GM Bulletin No.: 15435B
Date: July 2015

SB-10059121-5477

SUBJECT: Service Update for Inventory and Customer Vehicles
Torque Converter Machining Spill
Expires with Base Warranty

MODELS: 2015 Chevrolet Silverado HD
2015 GMC Sierra HD, Sierra Denali HD
Equipped with Allison 6-speed Automatic Transmission (RPO MW7)

PART INFORMATION

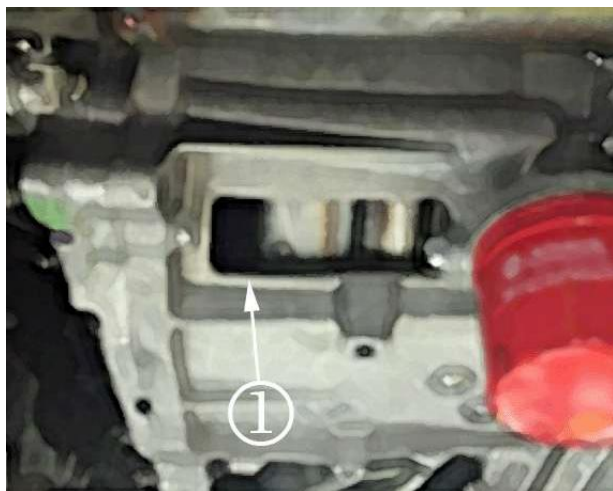
Since the torque converter housing is not being removed and no internal transmission repairs are required, the Part Information section has been revised to delete two gaskets and a seal which were erroneously included. Please discard all copies of bulletin 15435A.

Part Number	Description	Quantity/Vehicle
29546573	Torque Converter	1
88861037-US 19264717-CN	DEXRON®-VI Automatic Transmission Fluid	10 quarts
24263164	Gasket, Trfer Case Adap	1
15126137	Seal, Exhaust System (4-hole Gasket)	1
23170499	Prop Shaft Yoke Retainers	2
11548472	Prop Shaft Bolts	2
11611401	Transmission Mount Bolts	2
